SERVICE BULLETIN NO. 142**Visual Cooking – Oven size 1.20 – Adjustment of flaps on centre piece in oven chamber**

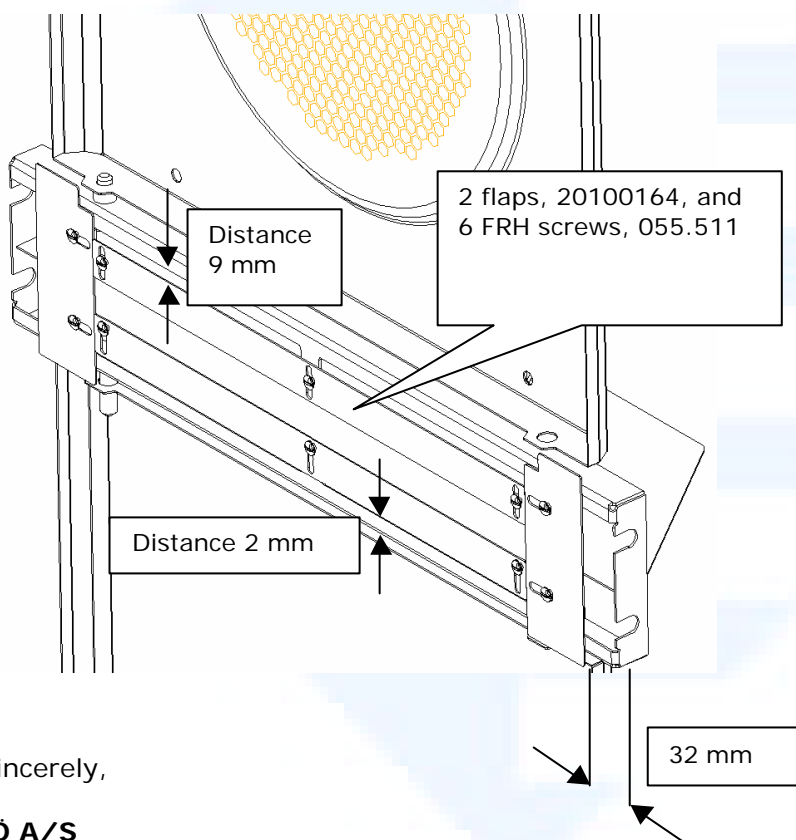
To optimise Visual Cooking oven model 1.20, we have introduced 2 flaps, part No. 20100164, to make it possible to control the flow of air.

Standard settings from the factory:

Gap, upper flap	: 9 mm
Gap, lower flap	: 2 mm
Gap, both sides	: 32 mm
